## Response to reviewers

MS essd-2021-466

“Optical and biogeochemical properties of Belgian inland and coastal waters”

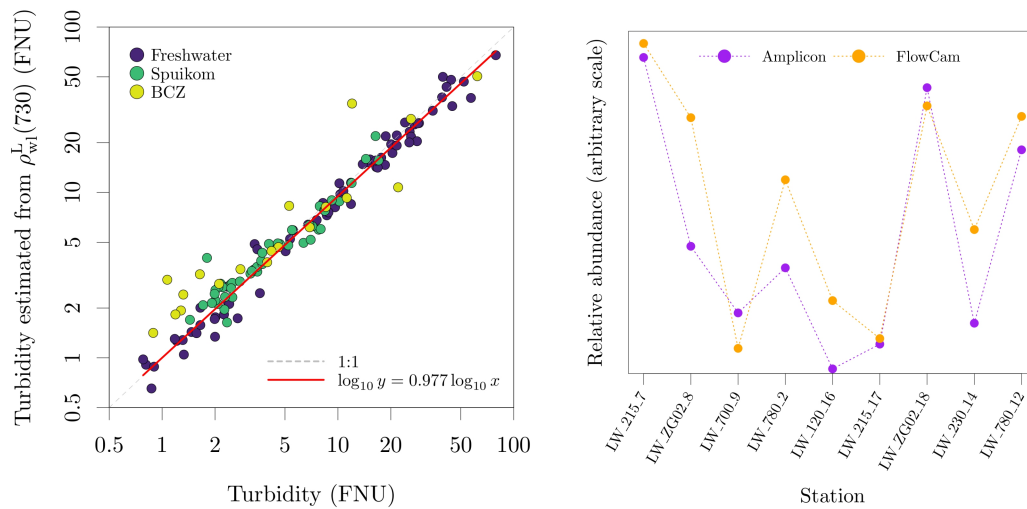
5) Labels of axes in Figure 9 and Figure 14 are not correctly spelled.

*The labels are correct in the original figures, though the preprint pdf has blanks covering part of the text. This likely happened during pdf generation by the*

*production team. We will be vigilant that the proofs are corrected for such errors. The original plots are reproduced below.*

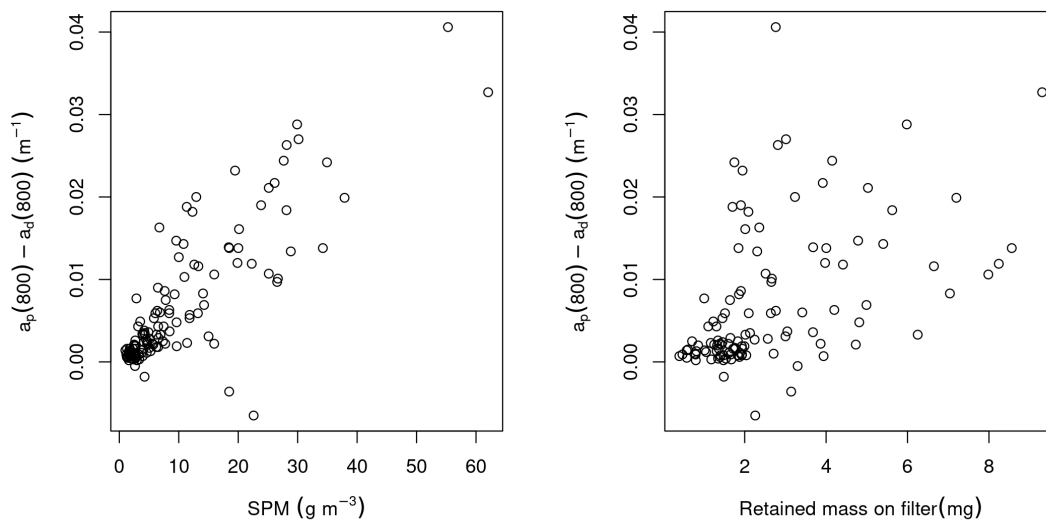
L216: is it: proportional to the concentration of particles and organic matter or is it: proportional to the organic fraction concentration of the particles? Please clarify as this is confusing.

*The former interpretation is correct. According to our data, the effect does not seem related to the organic fraction (i.e., relative) of particulate mass. Instead, it shows a linear relation to the particle load in the environment (SPM) and the organic particle load ( $\text{SPM} * (1 - \text{MF})$ ), i.e. absolute. This effect could have a small artifact contribution of filtration, but we would not classify it as an artifact since the relation to particle mass retained on filter is much less clear than to the particle concentration in the environment. See attached plots below.*

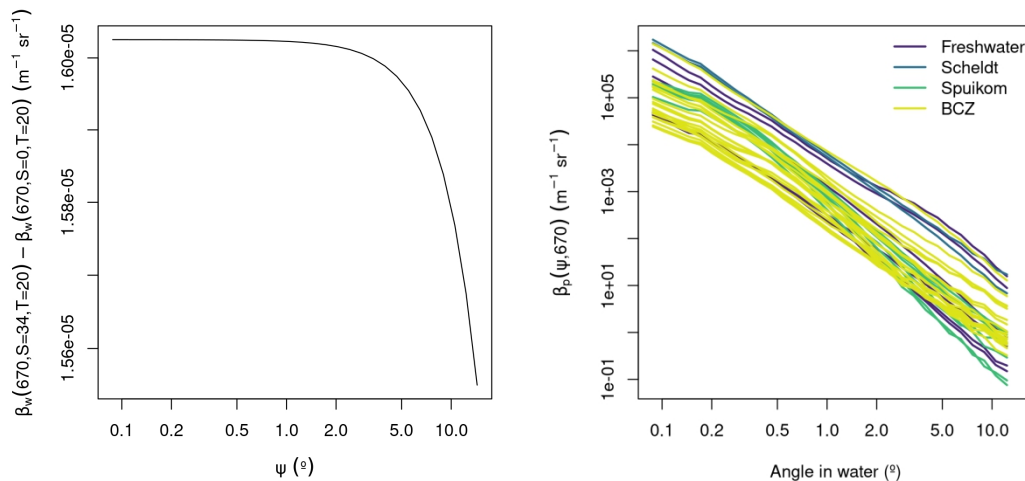
L250: what is the effect of salt water on the VSF at these angles? I am asking as you calibrate with deionised water-should you calibrate with pure filtered seawater?

*The additional scattered signal in the 2.5 cm or 5 cm path (depending on instrument model) arising from salt-solvated water is negligible in this waters considering the load of particles. See attached plot below on the difference of salt-solvated water VSF to pure water VSF at 670 nm and 20°C for the range of angles of the LISST instruments (Zhang and Hu, 2009; Zhang et al., 2009). Those values are negligible when compared to the measured VSFs.*

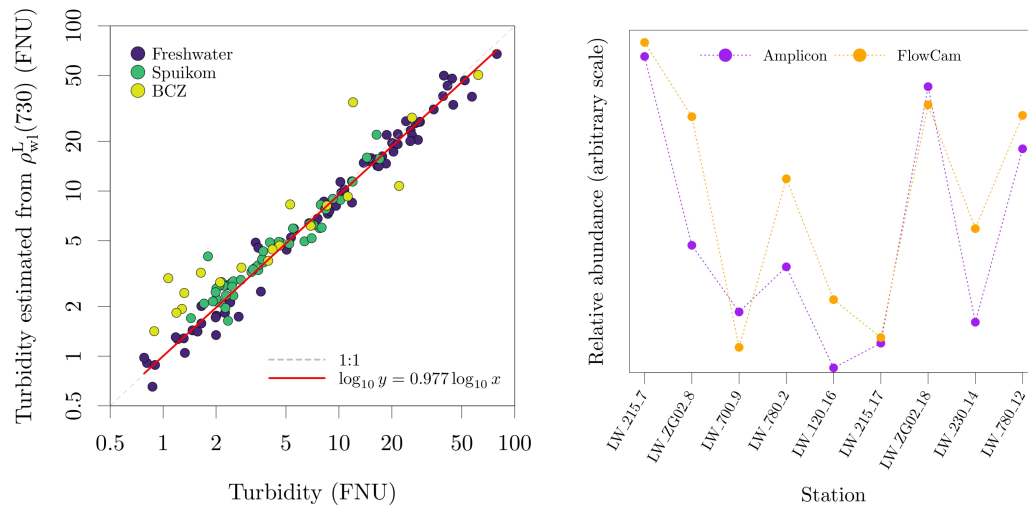
+ - L 478: Figure 14 Y-axis : elati e abundance???? What does that mean?

*This label (and also for Fig. 9) is correct in the original figures, though the preprint pdf has blanks covering part of the text. This likely happened during pdf generation by the production team. We will be vigilant that the proofs are corrected for such errors. The original plots are reproduced below.*

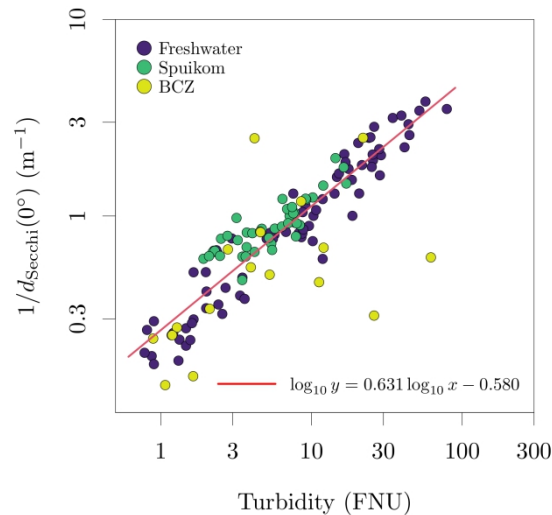
Section 2.4.1: This section needs improvement!! The authors say "measured and corrected values are provided"... and then nothing ! No description of values, why? On the other hand, it is written "a tentative correction for the effect of sun zenith angle ... was applied". I looked at the data. There are 5 values (DK\_01, SP\_08, SP\_21, SP\_42, SP\_46) which show corrected secchi values stronger than depth ?? This raises questions about the relevance and quality of this correction. Without discussion of its values or caveat on their quality, I recommend removing corrected secchi values from the database. Finally, why did the authors not apply a quality control for this parameter ? There are many algorithms in the literature comparing either turbidity to SPM or turbidity to IOPs.

*As we understand it, the value of the Secchi disk bears no relation on how far from the bottom it is, but how far from the surface. The bottom is an impediment to measure the correct Secchi disk depth in "optically shallow" and that is why the Secchi at the bottom is recorded with a special value to indicate that (in our case, a negative value). Therefore it is logically valid, and ecologically informative, to have corrected Secchi disk depths that are deeper than the bottom. The inverse of the Secchi disk should be proportional to the turbidity, as the fraction of diffuse attenuation caused by scattering is more relevant than the fraction caused by absorption for secchi disk depth determinations (visual contrast between surrounding water and disk; Lee et al., 2015). Here we present the plot of corrected Secchi disk depth against turbidity. The larger variability is seen in the coastal waters, in particular for stations LW\_710\_11 (yellow point way above the line) and stations LW\_710\_6 and LW\_700\_9 (two right most yellow points below the line). We note that the Secchi disk depth measurements in the marine campaigns were performed by a different operator than at the other stations and that conditions at sea are more challenging for measurements of Secchi*

disk, particularly at medium to high turbidity. The relation between SPM and turbidity and between measured turbidity and turbidity inverted from reflectance suggests that the Secchi disk depth measurements have higher uncertainty.

We have added this plot to the supplementary material and added the following phrase to section 2.4.1: “A comparison between turbidity the inverse Secchi disk depth, corrected for the Sun zenith angle, shows a log-linear relation and is presented in Fig. S5 (supplementary material).”

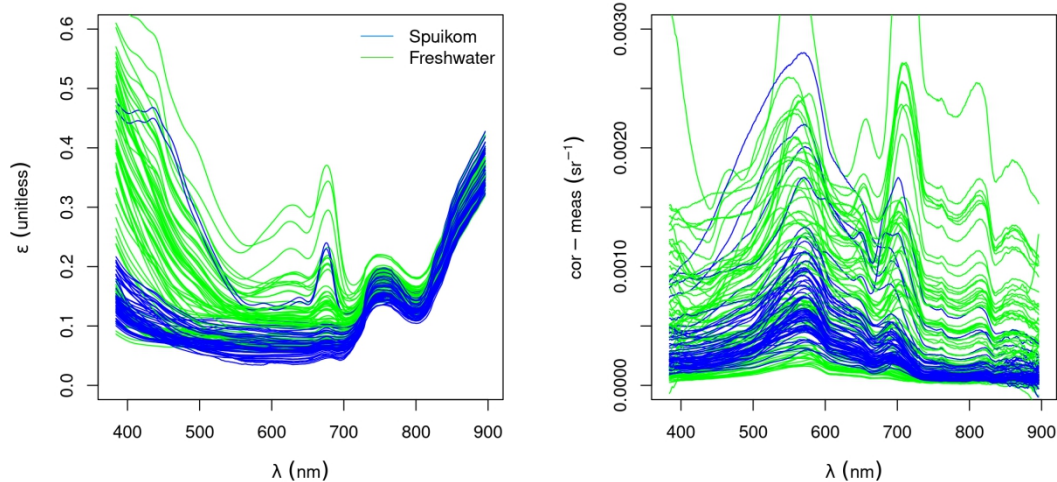
Section 2.4.2: how long is the acquisition session for a L<sub>wl</sub> measurement per station? How many spectra are acquired per session? You have to use the average spectrum I guess. Have you analyzed the standard deviation to possibly flag bad quality points? I looked at Figure S5. The spectrometer is hand-held. Can you guarantee that the lens's cylindrical shield at 2.5 cm below the water surface? Line 355, what are the average, min and max shadowing error values used to correct E<sub>dn</sub>? Line 368, what are the average, min and max values of the effective Fresnel reflectance used? Finally, you don't present any quality control for rho<sub>wl</sub>. Why not perform an optical closure exercise between measured rho<sub>wl</sub> and IOPs?

*The acquisition of the series for each station is concluded in less than 2 minutes (typically less than 1 min) with the Skylight-blocking method. The procedure is: 5 spectra are acquired over the plaque, then the shield's extension to the lens is submerged and 10 water-leaving radiance spectra acquired, then the tip is removed from the water, dried with paper and another 5 spectra are acquired over the plaque. We have added the following sentence: “A total of 10 L<sub>wl</sub> spectra and 5 plaque exitant radiance spectra were averaged per station, with the measurement sequence completed within 2 min.”*

*We understand the reviewer's considerations related to the limited control of handheld spectroscopic measurements. However, even if the system was not handheld (cf. Lee et al., 2013), it would not be possible to guarantee, under any realistic condition, the exact depth. The same is true for all spectroscopic measurement methods and in practice ranges around the nominal values are accepted (depth,*

angle). Considering that the shield extension is only 5 cm long, the maximum range of depth is  $\pm 2.5$  cm from the nominal, though a statistical argument can be used to support that most measurements are made closer to the nominal depth of 2.5 cm.

We have performed reasonable controls, corrections and validation to the data to ensure high quality. Closure is a challenging analysis. In part this is because scattering in the water system includes the contribution of turbulence and bubbles, and because inelastic scattering such as fluorescence of CDOM and phytoplankton pigments might not be correctly parametrized in the radiative transfer model. Also of importance is that we did not measure backscattering. However, following the argumentation presented above of turbidity as IOP, we can still present an equivalent analysis: The best support for the quality of the measurements is the linear relation between measured turbidity and turbidity estimated from the NIR (Fig. 9). The high absorption coefficient at 730 nm results in increased shadowing errors, which are also dependent on the IOPs and on the depth of the opening of the shield's extension. Figure 9 presents an acceptable variance around the 1:1 line.

The spectral shadowing errors estimated for the measurements and the difference (in  $R_{rs}$  units of  $sr^{-1}$ ) between the measured and corrected spectra are presented below:
